REQUEST FOR INFORMATION **DATE:** May 23, 2016 **NO.:** RFI-105

Project Name: Webster University Interdisciplinary Science Building Project No.: 15051

Subject: stud wall needed at room 133B

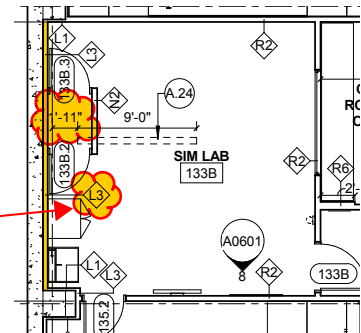
Room 133B SIM Lab shows a furring strip at the exterior West wall, which contains a sink. The plumbing for the sink requires a 3-5/8" stud wall (minimum) to contain the piping. Please provide a 3-5/8" stud wall at this sink, or relocate the sink to an interior wall with a 3-5/8" stud (minimum).

Revise the furring partition at the exterior west wall at room 133B to type 'L3'.
See sketch with revised dimensions & partition type.
This revision will be issued in future addendum.
